Remarks

Amendments to the Drawings:

Appl. No. 09/695,647
Amdt. dated February 11, 2005
Reply to Office Action of October 13, 2004

FIGURE 1

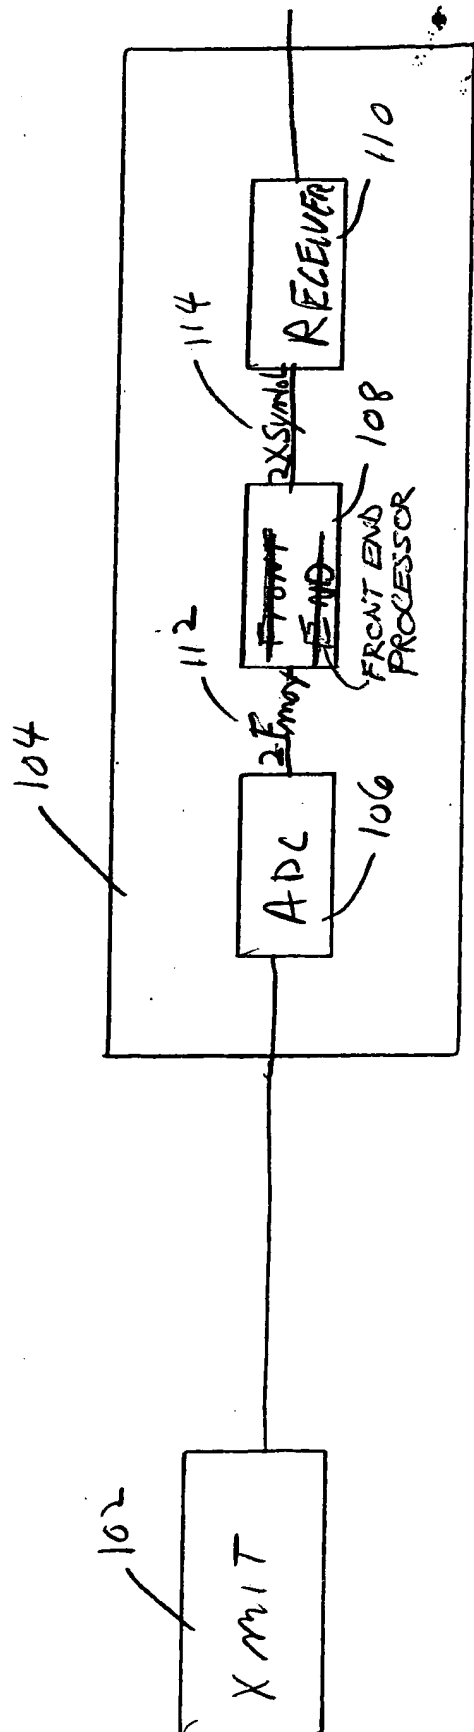
In Fig. 1, the title of element 108 has been changed from "Front End" to "Front End Processor". Support for this change can be found at page 7, lines 19, 20, and 25 where the front end processor 108 is discussed.

FIGURE 2D

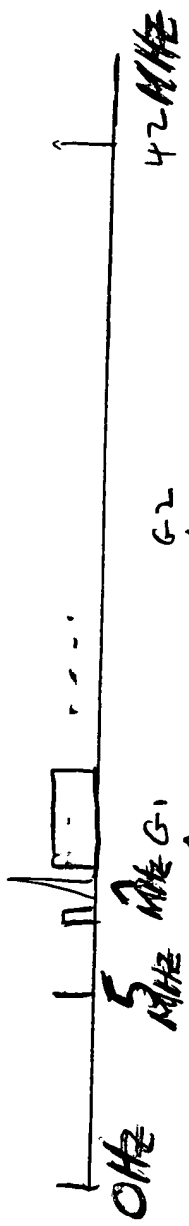
In Fig. 2D, frequency reference points are updated to include the 0 Hz reference point and adding MHz units to the 5 MHz, 7 MHz, and the 42 MHz reference points to be consistent with Fig. 2C, for example. The 7 MHz reference point is the point of interference noted in the specification discussion of Fig. 2D at page 8, lines 17-19.

FIGURE 3

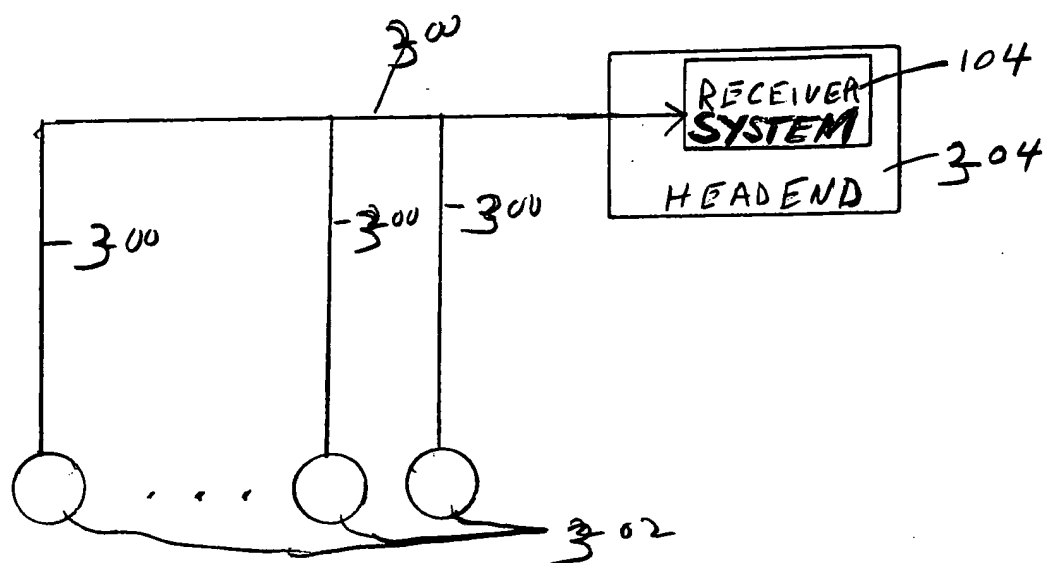
In Fig. 3, the title of element 104 has been changed from "Receiver" to "Receiver System". Support for this change can be found at page 7, lines 15-19 where the receiver system 104 of Fig. 1 is discussed.

FIGURE 6

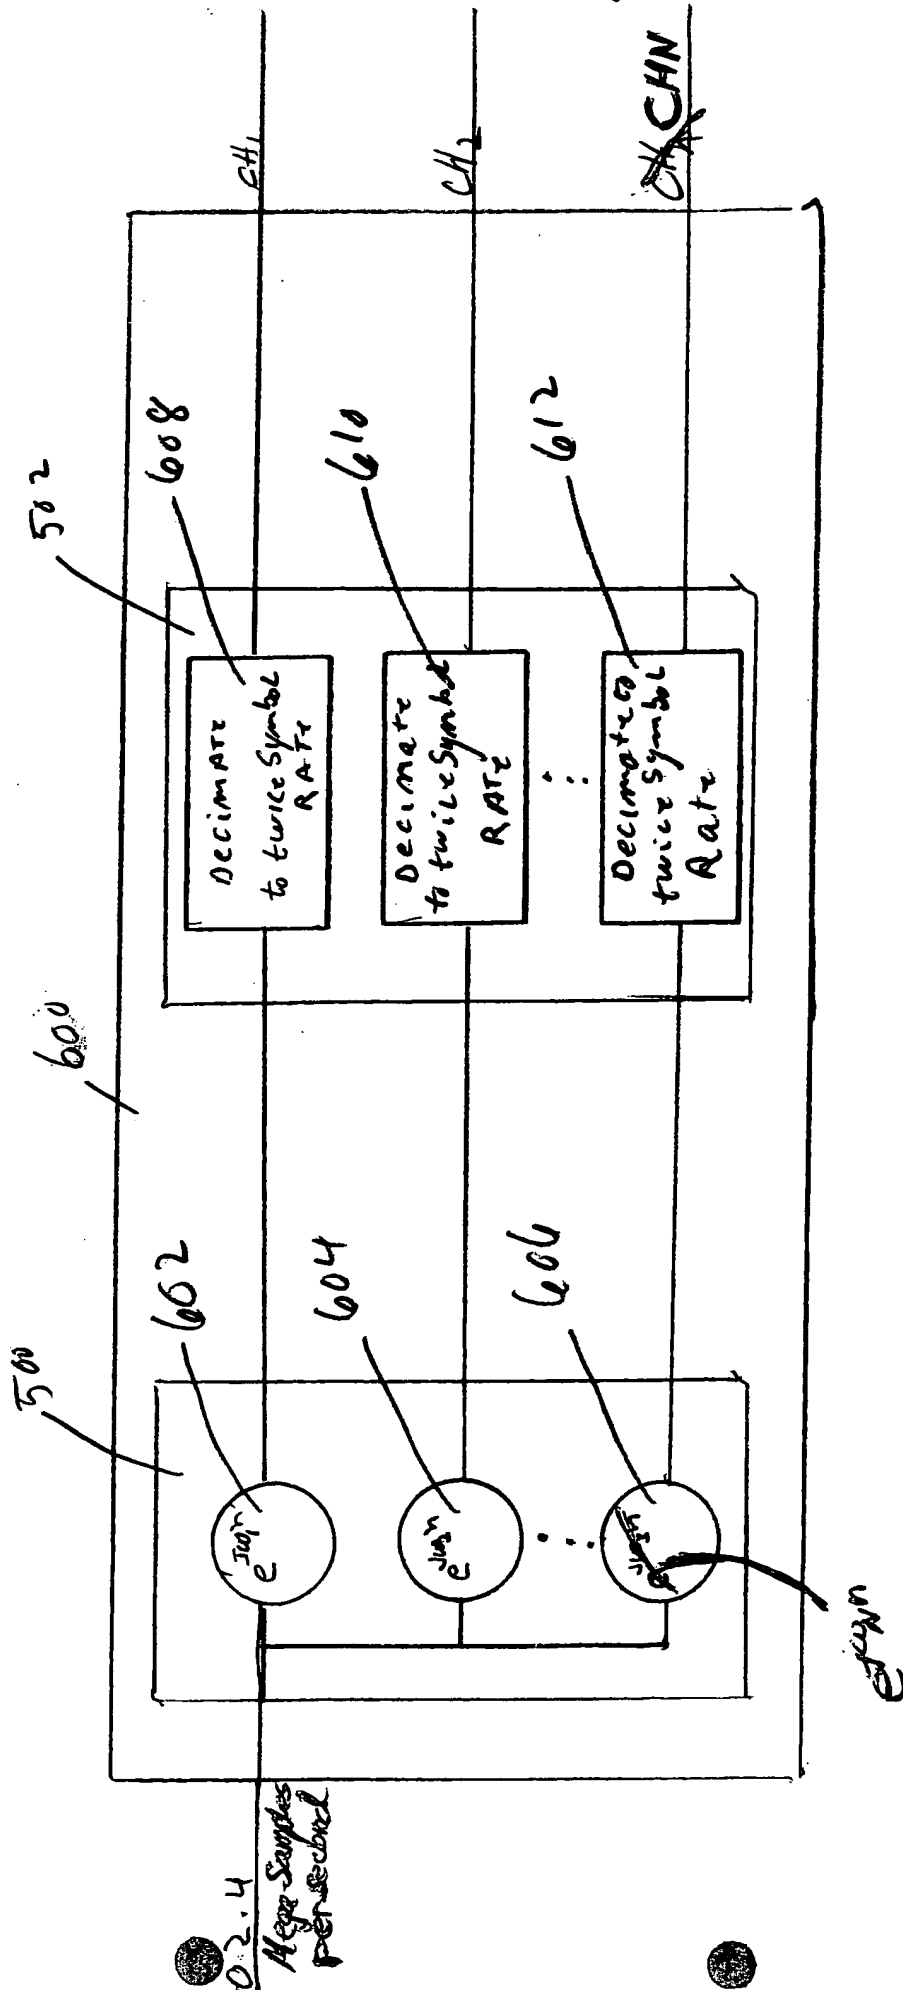
In Fig. 6, the input line labeled "102.4" has been changed to "102.4 mega samples per second" to correspond to the specification at page 11, lines 13-16. The subscript on the down-converter 606 is changed to N for the Nth channel represented in Fig. 6 and the output of decimator 612 is changed to CHN for the Nth channel. Support for these changes can be found at page 12, in lines 8-11 where it is indicated there are N channels within the upstream band and down-converters 602, 604, and 606 are dedicated to one of the N channels. Down converter 606

is the last down-converter in the series and consequently corresponds to CHN as also indicated by the CHN output of the decimator 612 connected to down-converter 606.

FIGURE 12

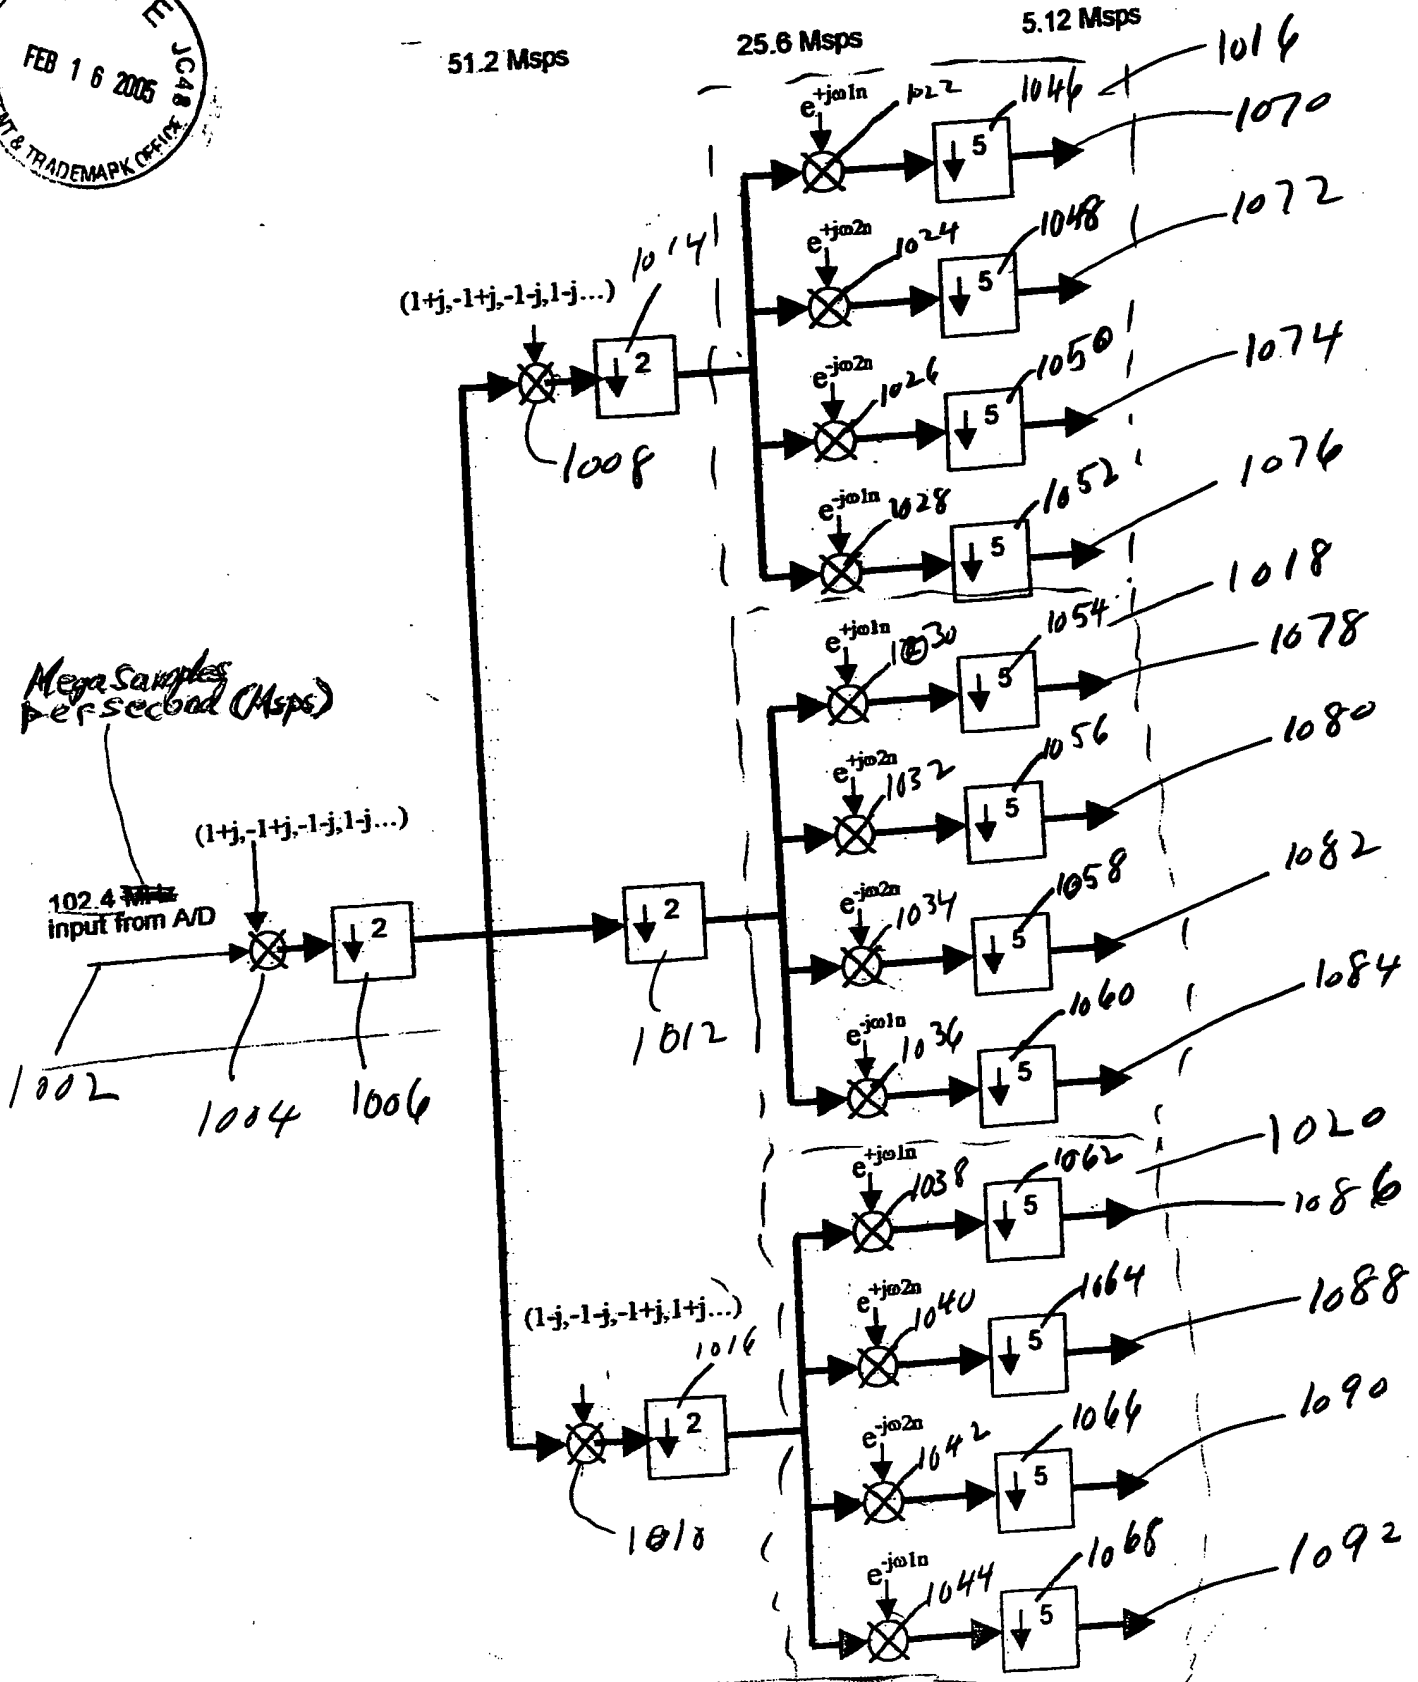
In Fig. 12, the I_n , Q_n , and $Data_n$ labels associated with data memory 1204 have been changed to correct the channel reference number for channel N, changing I_n , Q_n , and $Data_n$ to I_N , Q_N , and $Data_N$. These changes have been made to be consistent with the naming convention for channel N used in the specification and figures, such as Figs 5, 8, and 13, for example.
